ADDENDUM NO. 04 (MEPT)

Date of Issuance: April, 23, 2026

Project: **Replacement Elementary on Mustang Rd.**
Alvin Independent School District

Texas Arcadis Inc.
Project No.: 202502 - 30268973

1 Level 1 Plumbing Plan - AREA D1
1/8" = 1'-0"

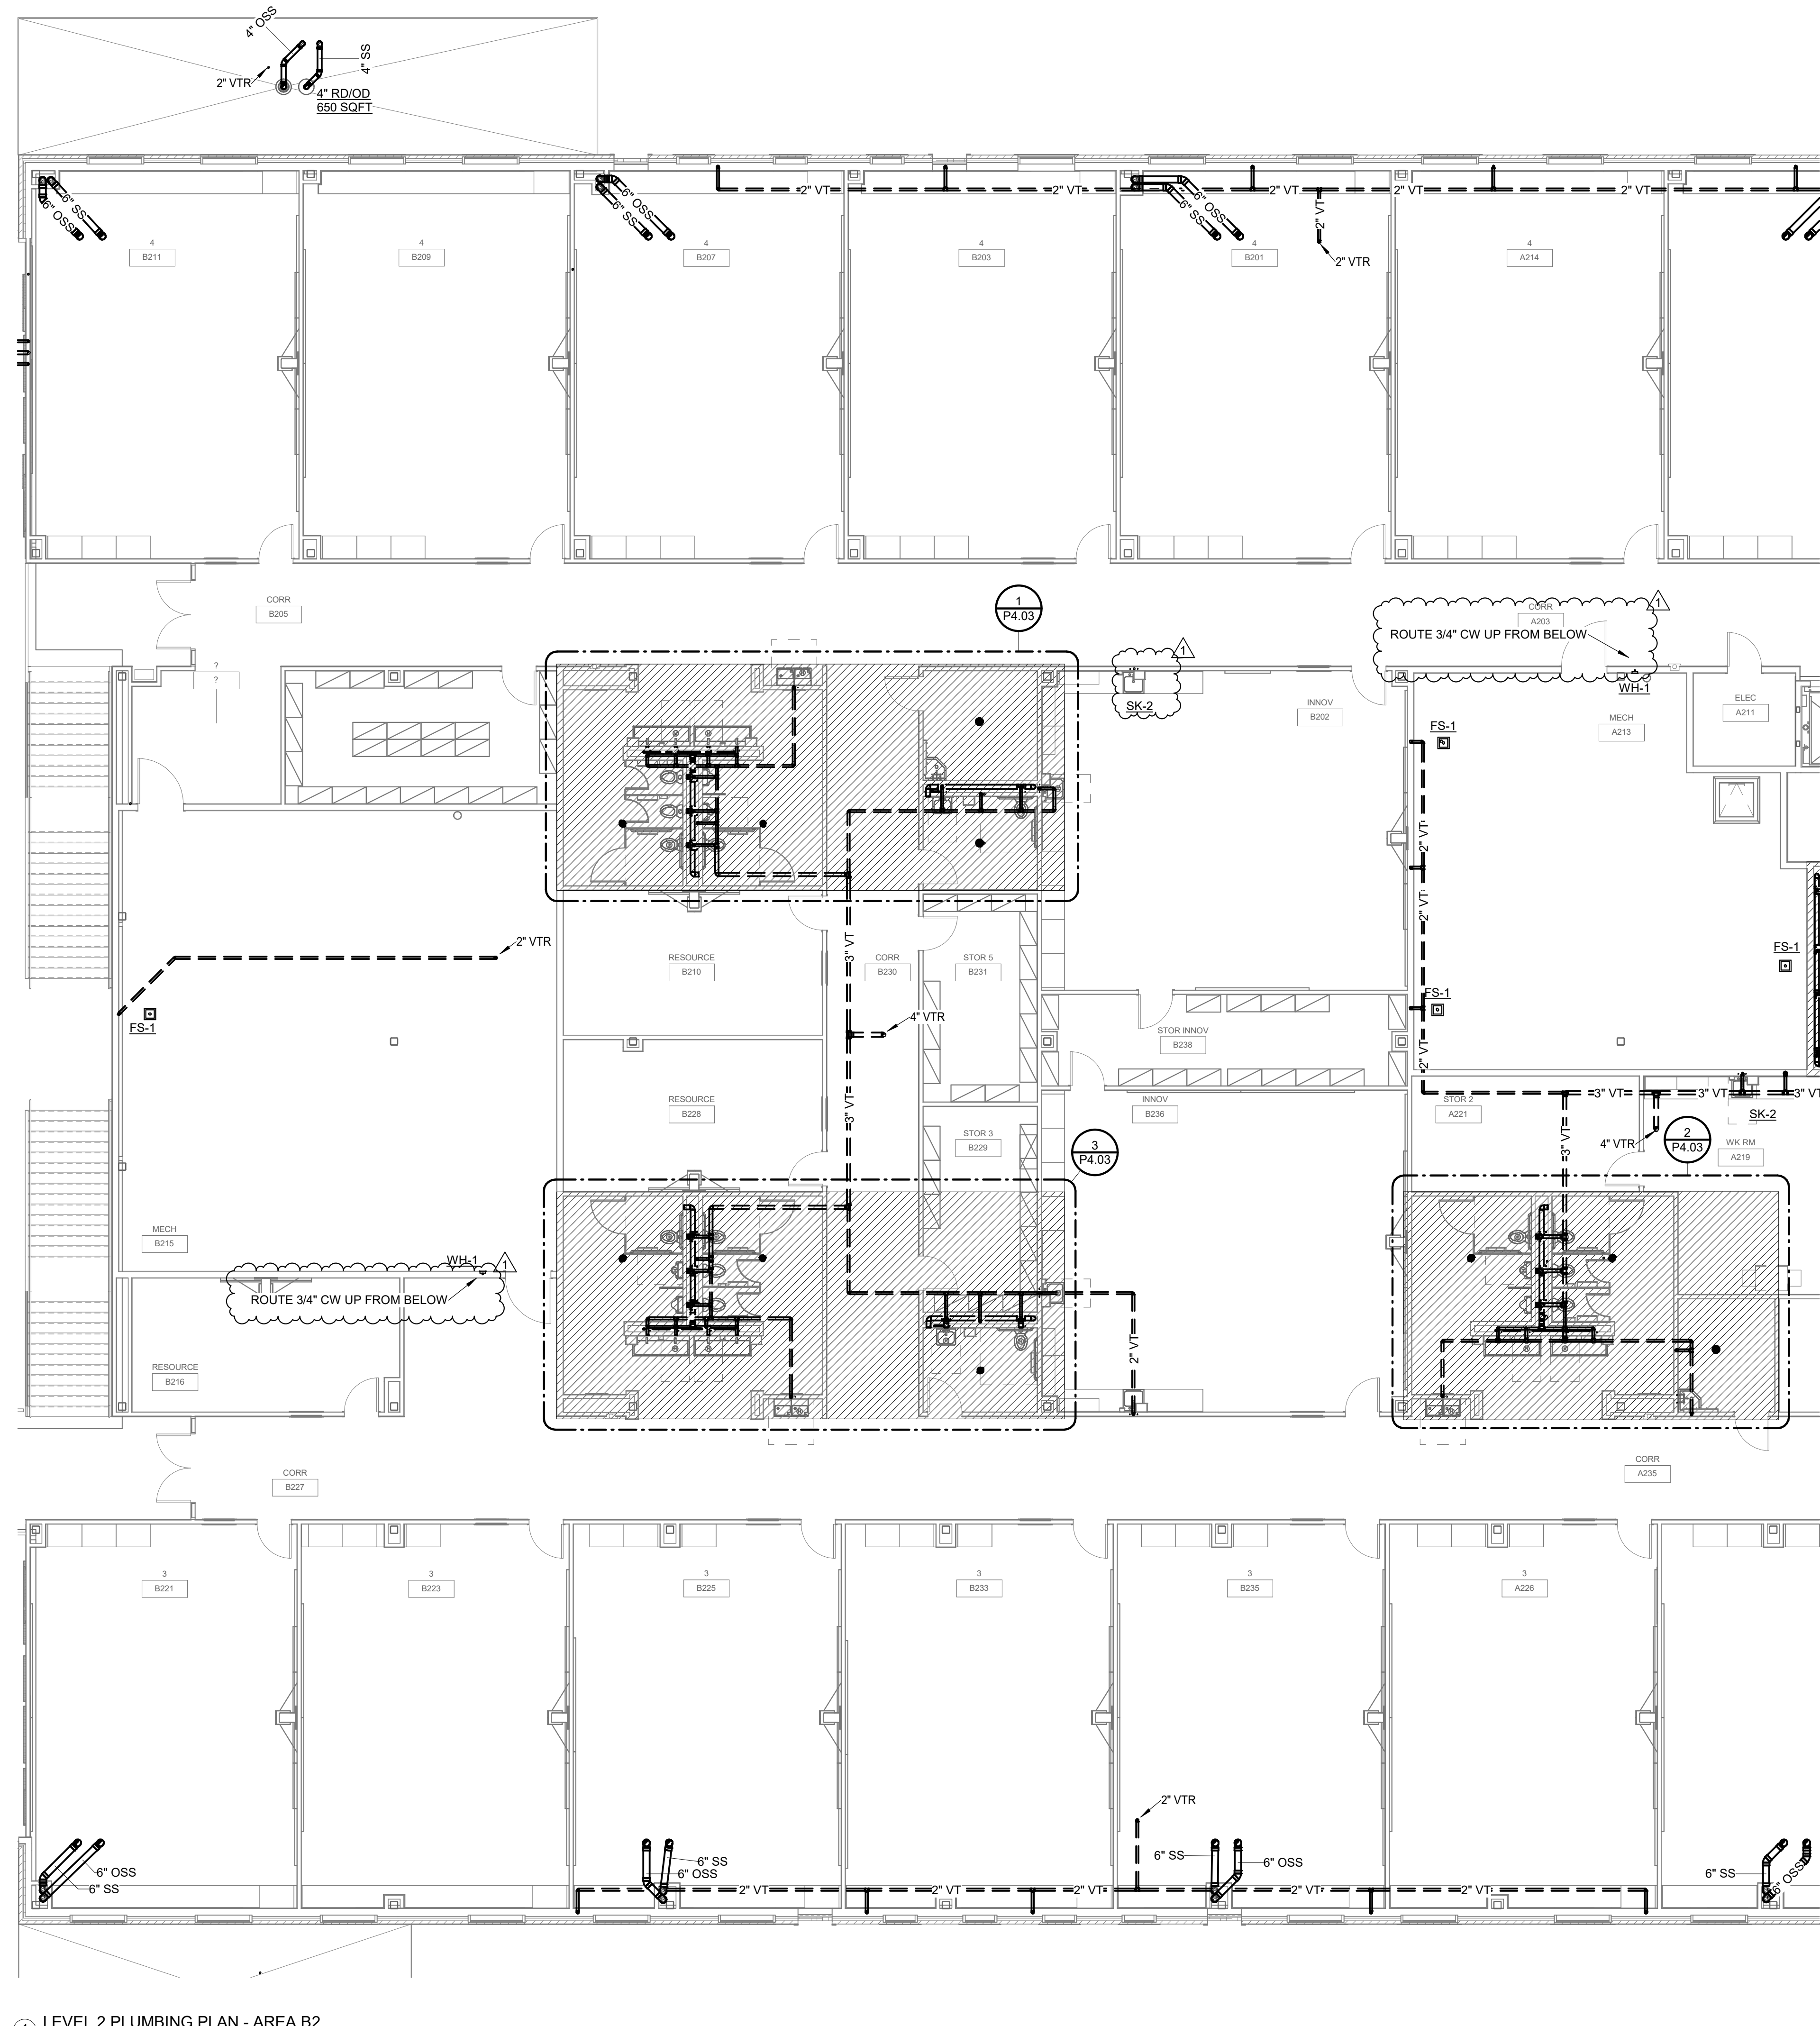
30. Sheet P2.14 – LEVEL 1 PLUMBING - AREA D1
 - c. Revised cold and hot water routing.
31. Sheet P2.22 – LEVEL 2 PLUMBING - AREA B2
 - d. Added routing notes.

1 LEVEL 2 PLUMBING PLAN - AREA C2
1/8" = 1'-0"

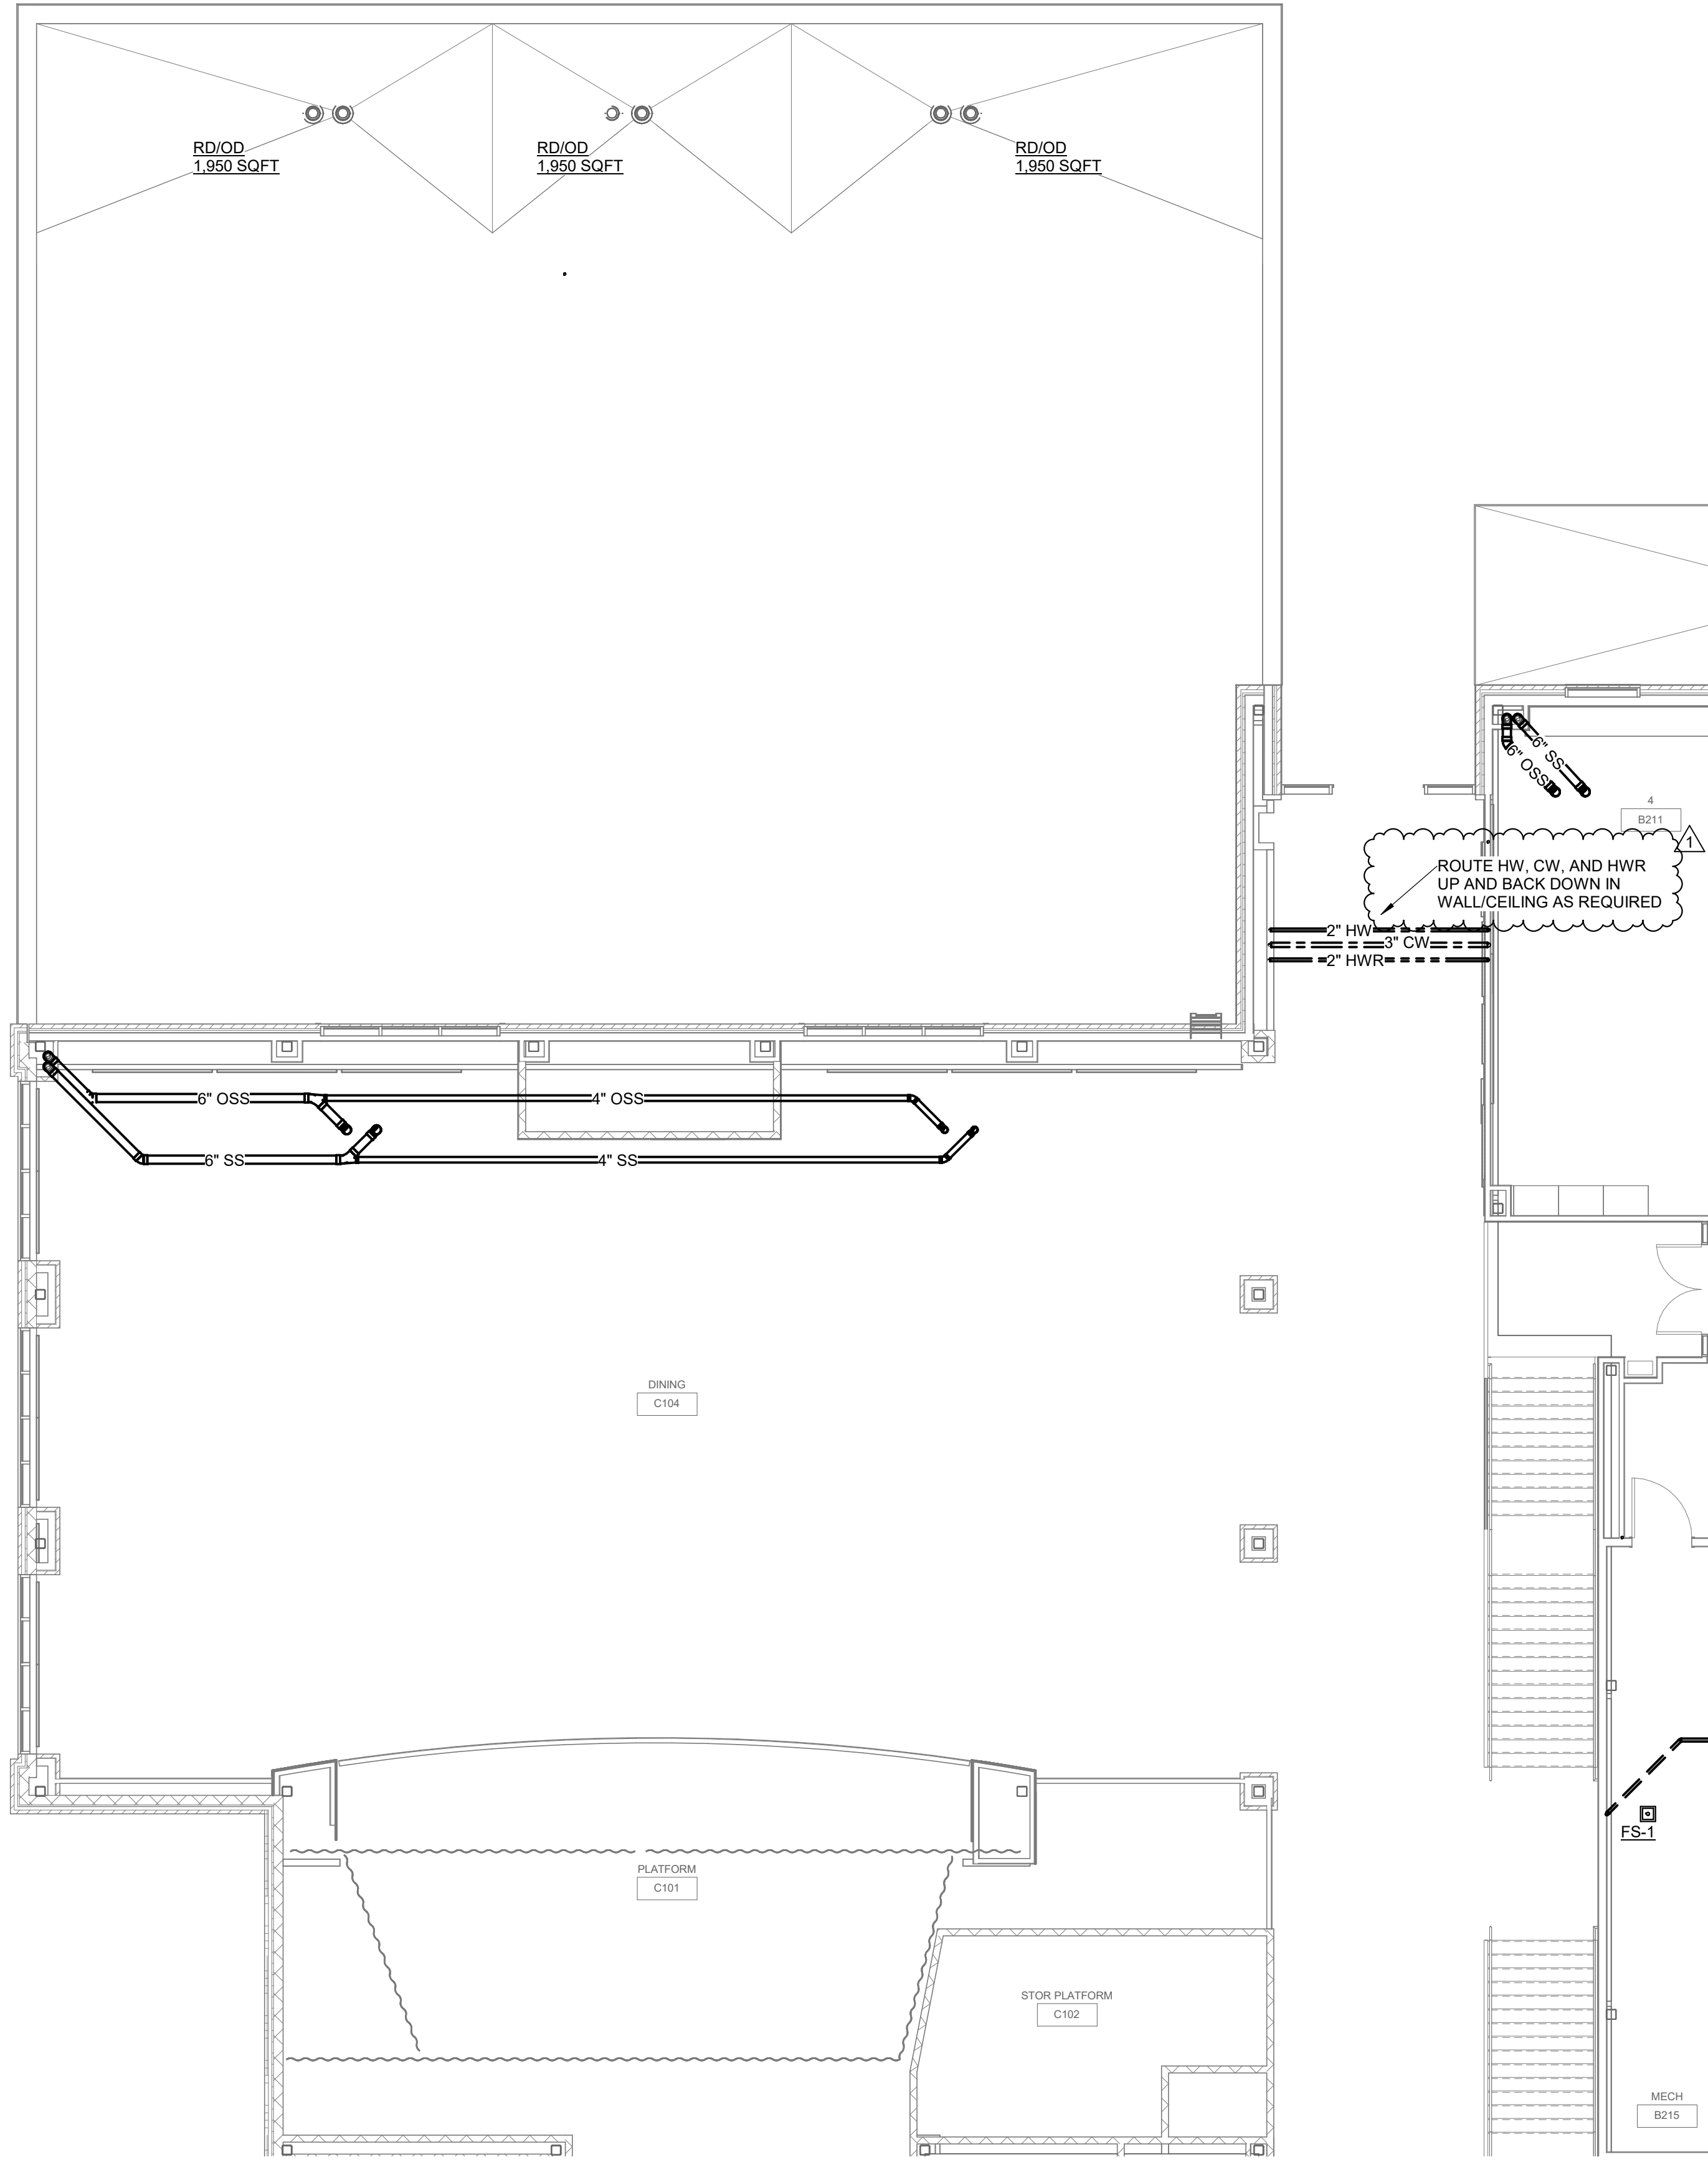
32. Sheet P2.23 – LEVEL 2 PLUMBING - AREA C2
 - e. Added routing notes.
33. Sheet P2.24 – LEVEL 2 PLUMBING - AREA D2
 - f. Added routing notes.
34. Sheet P4.01 – ENLARGED PLUMBING PLANS
